Architect's Supplemental Instructions

Architect's ASI No: 061

Project:
Webster University
Interdisciplinary Science
Building

Description: ASI – 061 (RFI-509)

Drawings:
P0402 – Risers – Plumbing

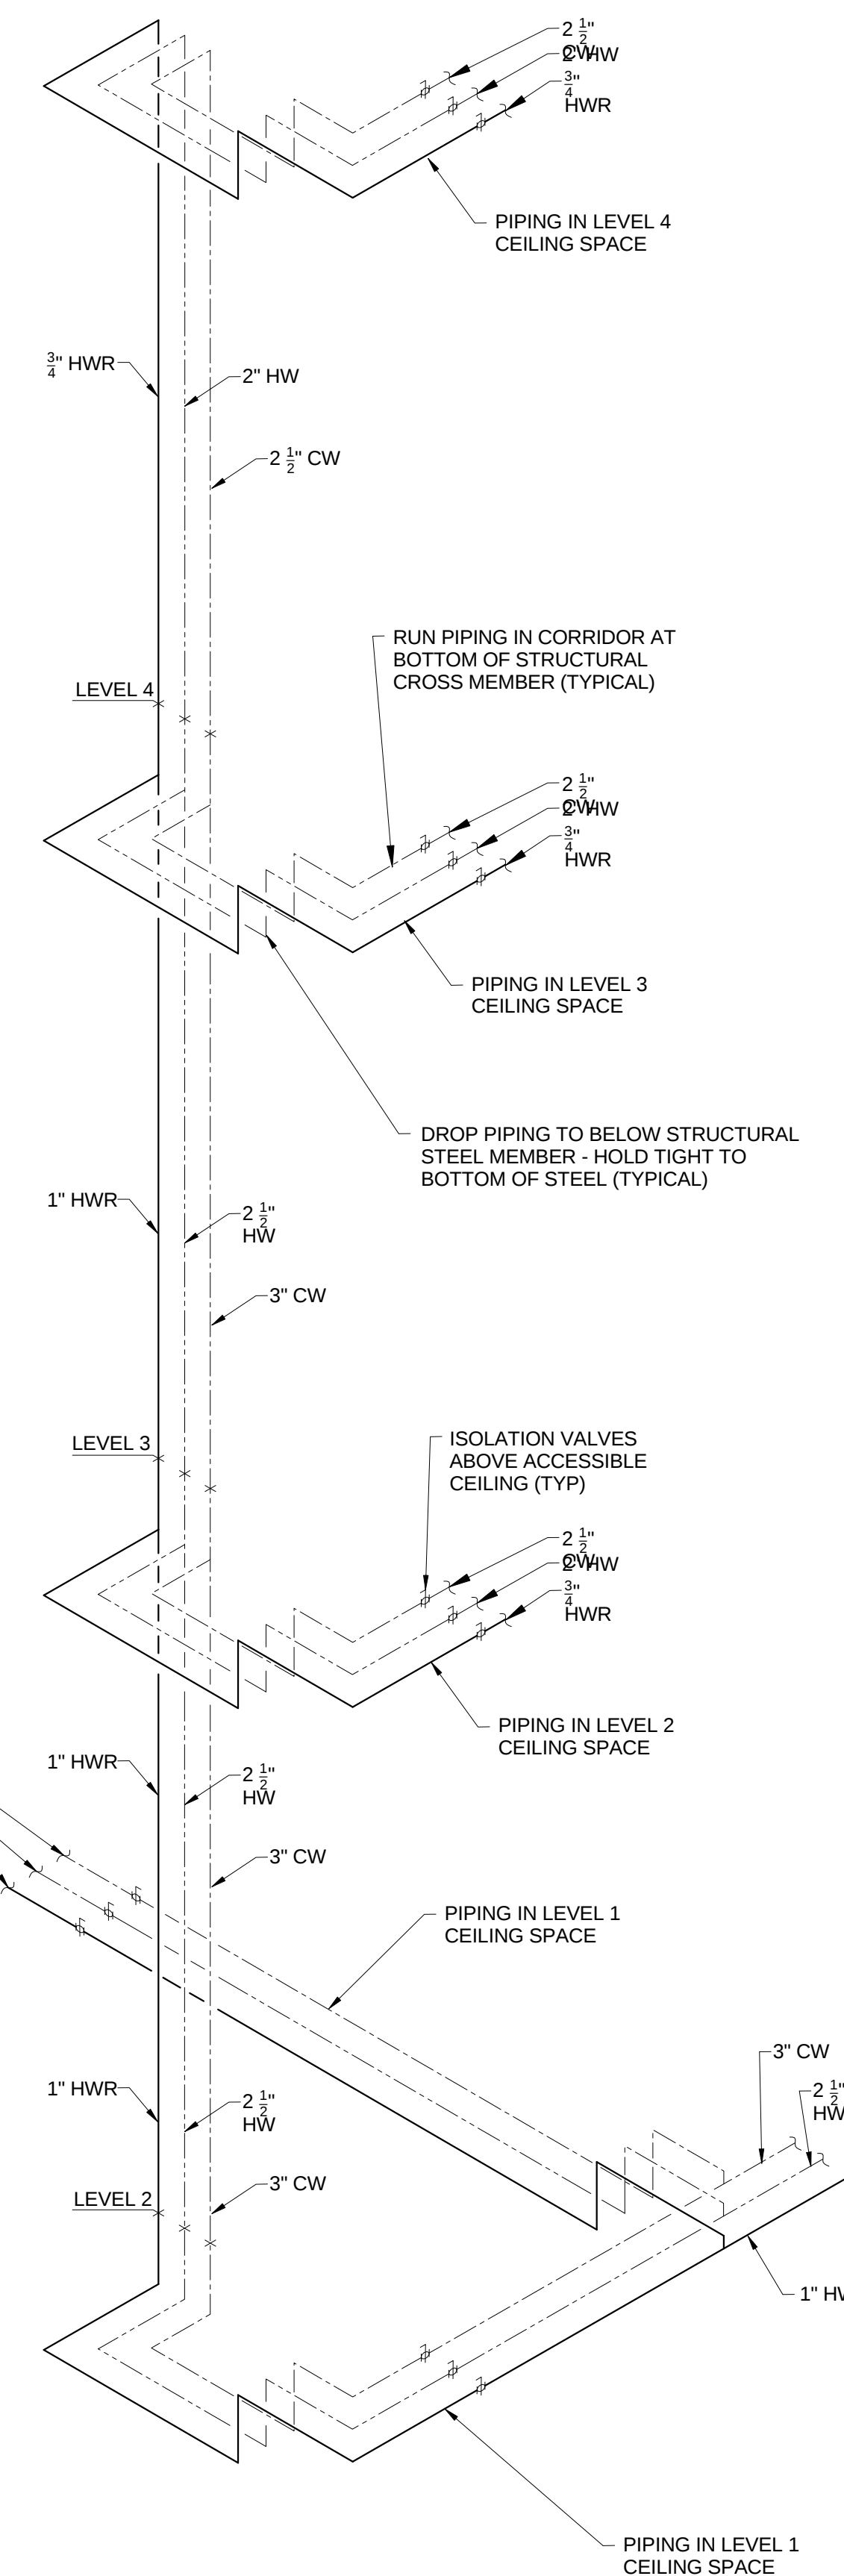
ASI-061 is being issued for the purpose of replacing the water supply valve in DW-1 that serves the under-counter dishwasher in Teaching Kitchen 174. The new valve to provide ½" inlet and ¾" hose end connection outlet. Valve shall be Guy Grey model 88400 or approved equal.
